RE: RESPONSE TO COMMENTS ON THE FEASIBILITY STUDY
CENTRE COUNTY KEPONE SITE, STATE COLLEGE, PA

RESPONSE TO COMMENTS ON DRAFT FEASIBILITY STUDY
DATED OCTOBER 15, 1993

FIGURE **1**

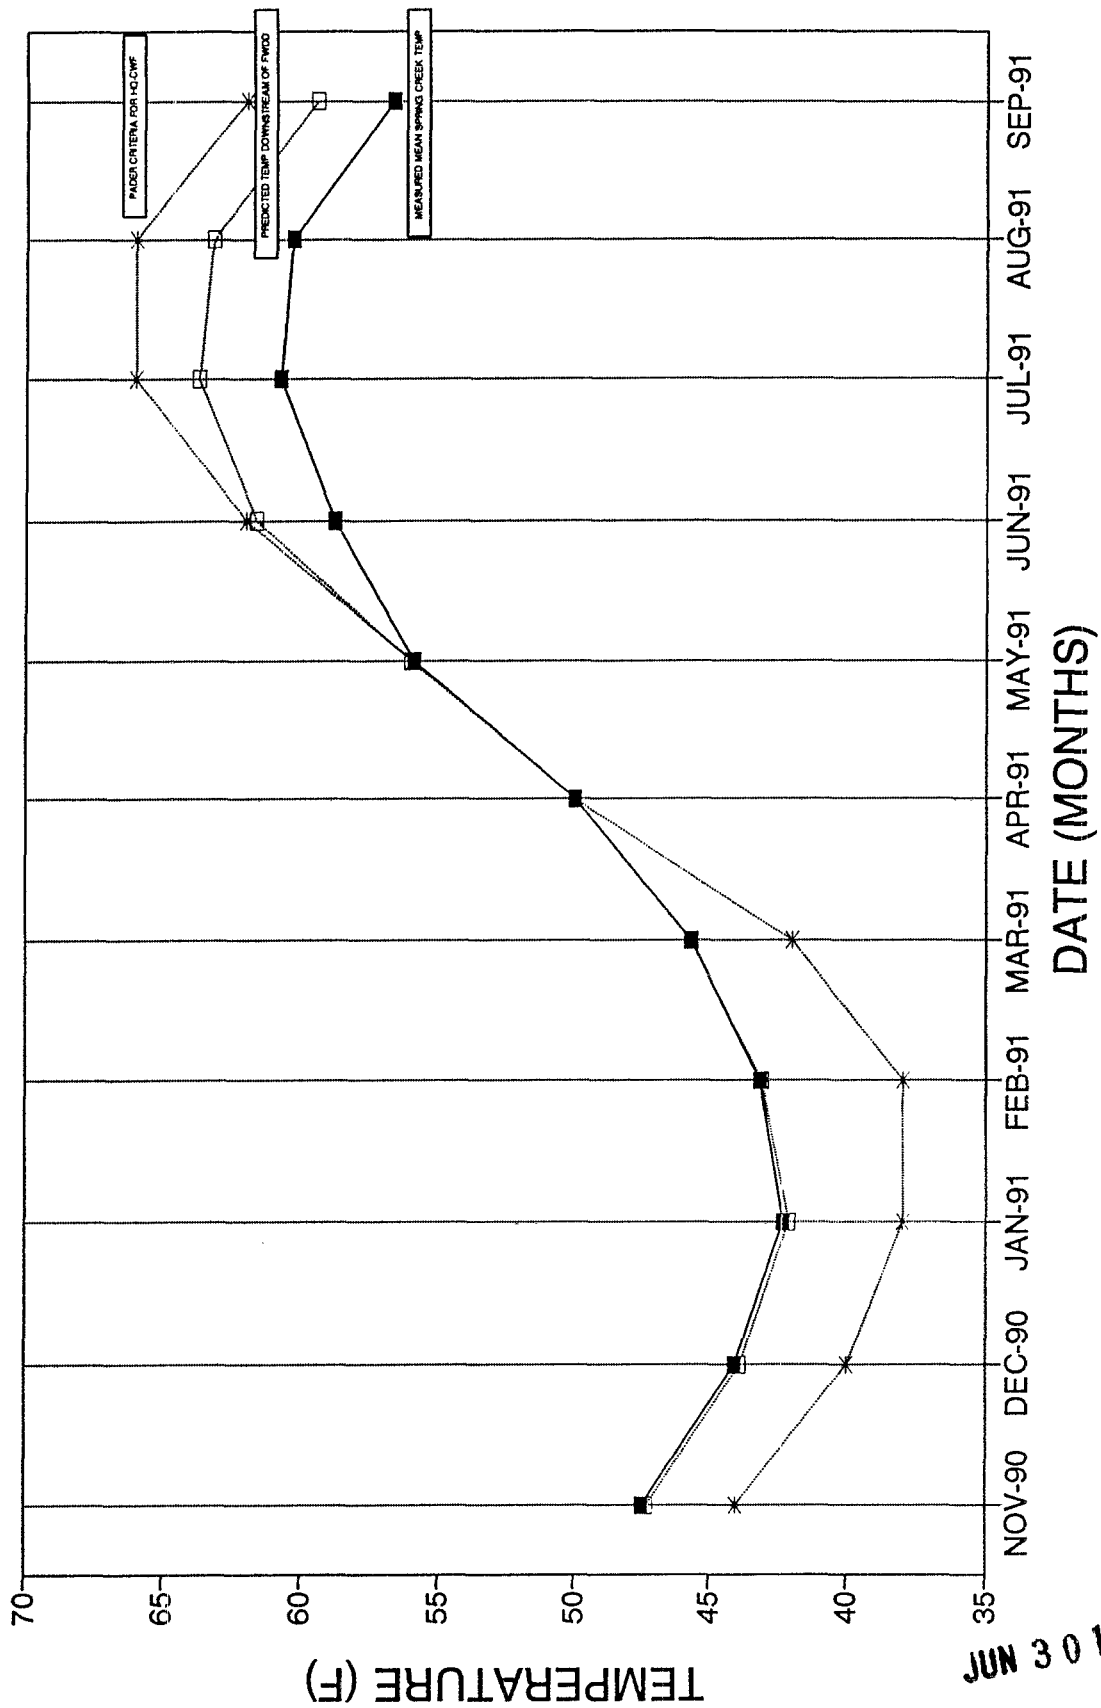
Comment: Interception of Thornton Spring bound groundwater will not effectively treat spring water. High spring flows, which had higher VOC concentrations, would not be treated to counter the higher potential environmental damage. Discharge of pumped groundwater away from the spring alters groundwater contributions to Spring Creek near Pike Street and may cause thermal problems during drought. (PFBC)

Mean monthly temperature data for Spring Creek upstream of Lemont for the period of November 1990 through September 1991 were reported by Carline, et. al., and are summarized in Figure 1 of this document. Temperatures of the Thornton Spring discharge were estimated from groundwater temperature measurements presented in the Final RI Report which are consistent with a recent field observation at Thornton Spring. The temperature of Thornton Spring was assumed as constant since groundwater temperatures typically do not vary more than 2° to 3°F throughout the year

Flow estimates for Spring Creek immediately upstream of Thornton Spring were obtained from the RI Report. The February 5, 1991 measurement was utilized as a representative Low Winter Season Flow and was applied as a conservative Spring Creek flow from November to April. The Spring Creek Q7-10 flow as estimated in the RI Report was applied as a conservative summer drought flow from May to September. The reduction in Thornton Spring flow and increase in discharge from the FWDD was assumed as the projected treatment plant discharge of 240 gpm.

Figure 1 presents the resulting estimated Spring Creek temperature downstream of the FWDD, together with the observed mean Spring Creek temperatures upstream of Thornton Spring, and the PaDER criteria for High Quality - Cold Water Fishes (25 PA Chapter 93).

As indicated on Figure 1, during the period of November through June, the observed mean Spring Creek temperatures upstream of Thornton Spring under current conditions equal or exceed the PaDER criteria. During the period of November through February, implementation of a remedy which involves decreasing the flow in Thornton Spring and increasing the flow in the FWDD reduces Spring Creek temperatures and contributes positively towards compliance with PaDER criteria. During the period of March through May, no effect is predicted on Spring Creek temperatures and between June and September, the temperatures increase on the order of 2°F but are still below PaDER criteria.
